Subject: Response to Request for Additional Information for the Overall Integrated Plan for the Commission Order Modifying Licenses with Regard to Requirements for Reliable Spent Fuel Pool Instrumentation

James A. FitzPatrick Nuclear Power Plant
Docket No. 50-333
License No. DPR-059

JAF Spent Fuel Pool Instrumentation RAI Responses

Figure 1

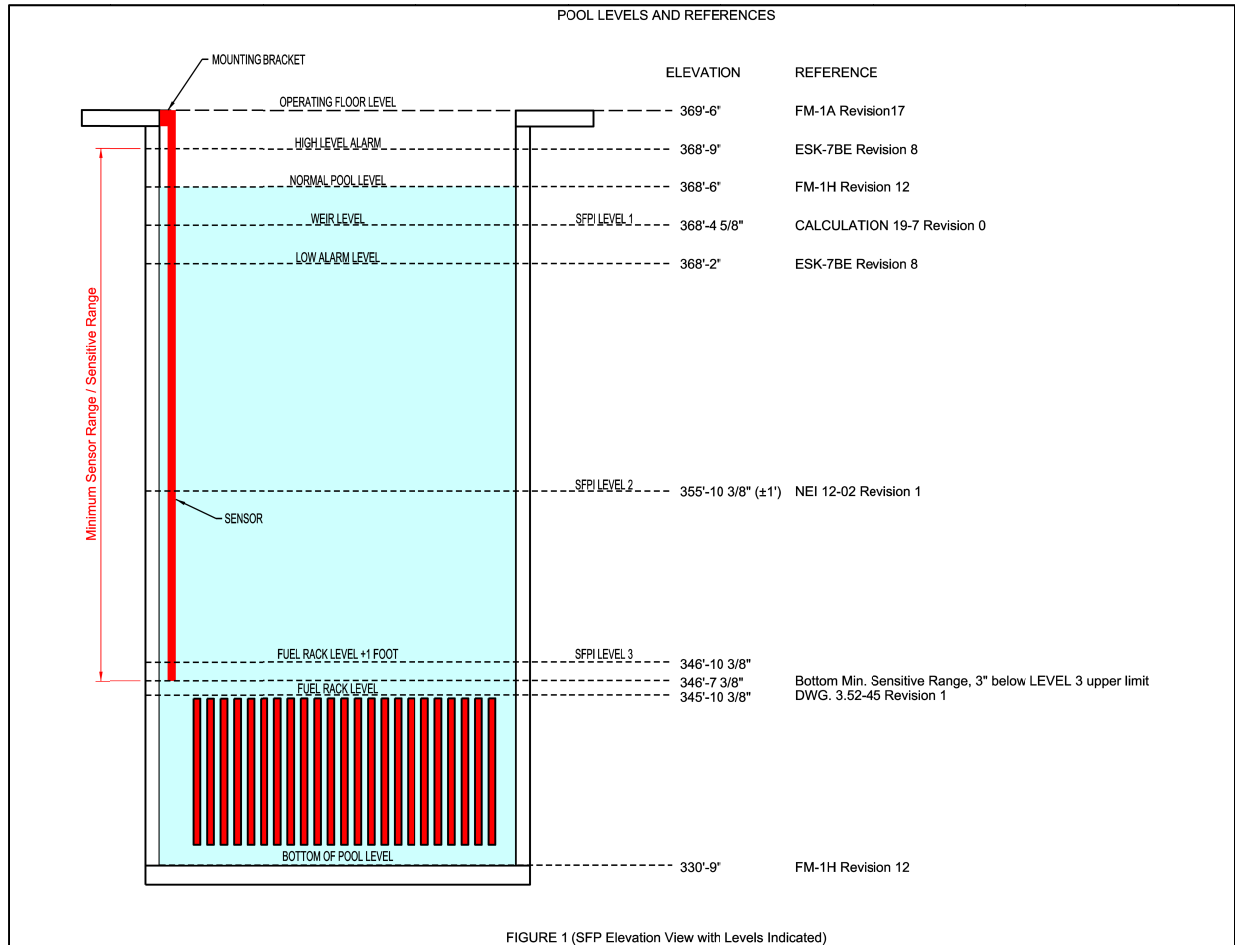
- a) **A clearly labeled sketch depicting the elevation view of the proposed typical mounting arrangement for the portions of instrument channel consisting of permanent measurement channel equipment (e.g., fixed level sensors and/or stilling wells, and mounting brackets). Indicate on this sketch the datum values representing Level 1, Level 2, and Level 3 as well as the top of the fuel racks. Indicate on this sketch the portion of the level sensor measurement range that is sensitive to measurement of the fuel pool level, with respect to the Level 1, Level 2, and Level 3 datum points.**

- a) The requested information is provided in Figure 1. The figure indicates Levels 1, 2, and 3 as well as the approximate location of the proposed mounting bracket incorporating the Seismic Category I attachment. The sensor is a perforated tubular coaxial waveguide that provides continuous level measurement axially and is sensitive over its entire length. The sketch applies to both the primary and backup channels.

The spent fuel pool (SFP) level lower instrument span or probe bottom extends down to at least three inches below the upper limit of the range of Level 3 to account for channel accuracy or instrument loop uncertainty. Therefore, the SFP level probe bottom/span extends down to at least elevation 346 feet 7-3/8 inches (see Figure 1). The SFP level upper instrument span includes the high water level alarm elevation.

Figure 2

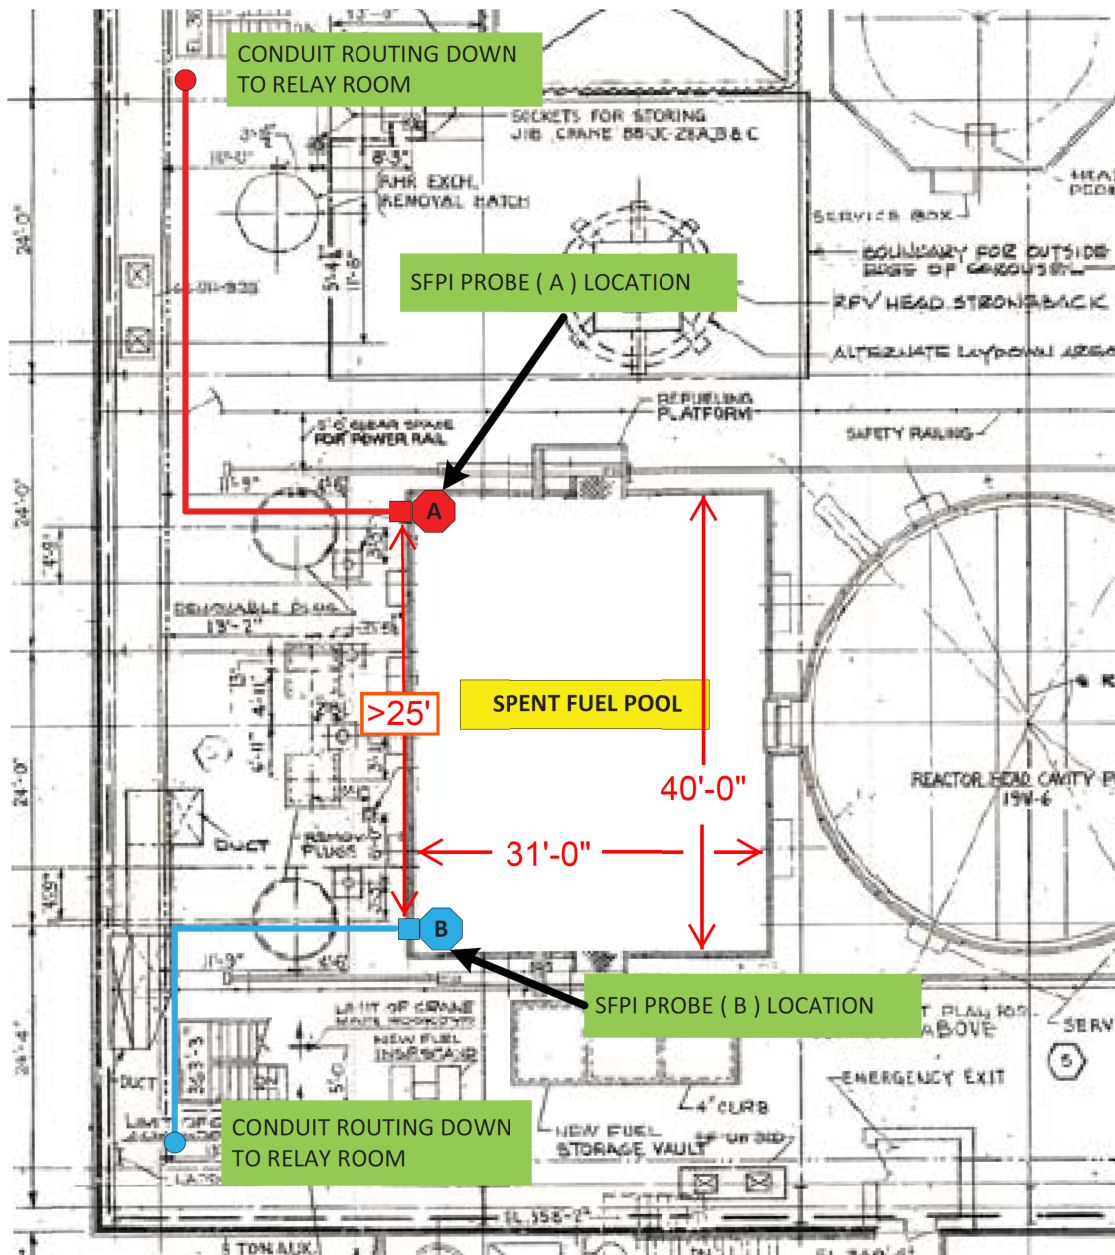
Please modify the marked-up plant drawing in Attachment 1 of the plan view of the spent fuel pool area, to clearly depict the spent fuel pool inside dimensions, the approximate separation in feet of the planned locations/placement of the primary and back-up spent fuel pool level sensors, and the proposed routing of the cables that will extend from the sensors toward the location of the local electronics cabinets and read-out/display devices in the main control room or alternate accessible location.

Figure 2 shows the approximate locations of the Spent Fuel Pool Instrumentation (SFPI) probes along with the inside dimensions of the spent fuel pool. The conceptual routing of the cables in the refueling floor area is available in Attachment 1 to the JAF OIP. Detailed design has not been completed at this time.

Figure 3

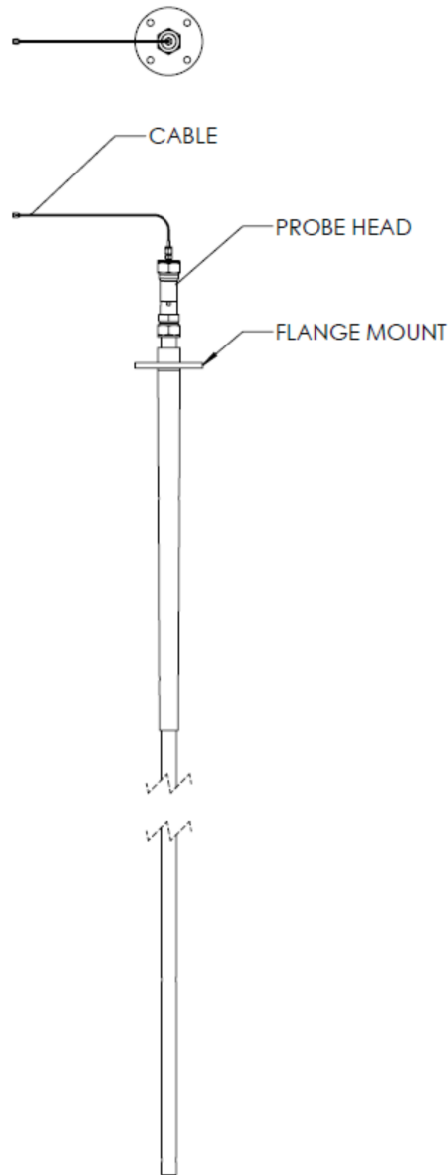
- b) A description of the manner in which the level sensor (and stilling well, if appropriate) will be attached to the refueling floor and/or other support structures for each planned point of attachment of the probe assembly. Indicate in a schematic the portions of the level sensor that will serve as points of attachment for mechanical/mounting or electrical connections.**
- c) A description of the manner by which the mechanical connections will attach the level instrument to permanent spent fuel pool structures so as to support the level sensor assembly.**
- d) Please describe how other material stored in the SFP will not create adverse interaction with the fixed instrument location(s).**

- b) The proximal portion of the level probe is designed to be attached near its upper end (refer to vendor schematic Figure 3) to a Seismic Category I mounting bracket configured to suit the requirements of a particular SFP. The bracket may be bolted and/or welded to the SFP deck and/or SFP liner/wall according to the requirements of the particular installation per Seismic Category I requirements.
- c) See RAI-3.b response above.
- d) An evaluation of non-special nuclear material inventory located in the SFP will be performed during the SFPI modification process. The storage of non-special nuclear material that is not stored in designated locations is governed by procedure AP-17.03, Spent Fuel Pool Material Control. This procedure will be used to prevent any instrument interference from non-special nuclear materials.
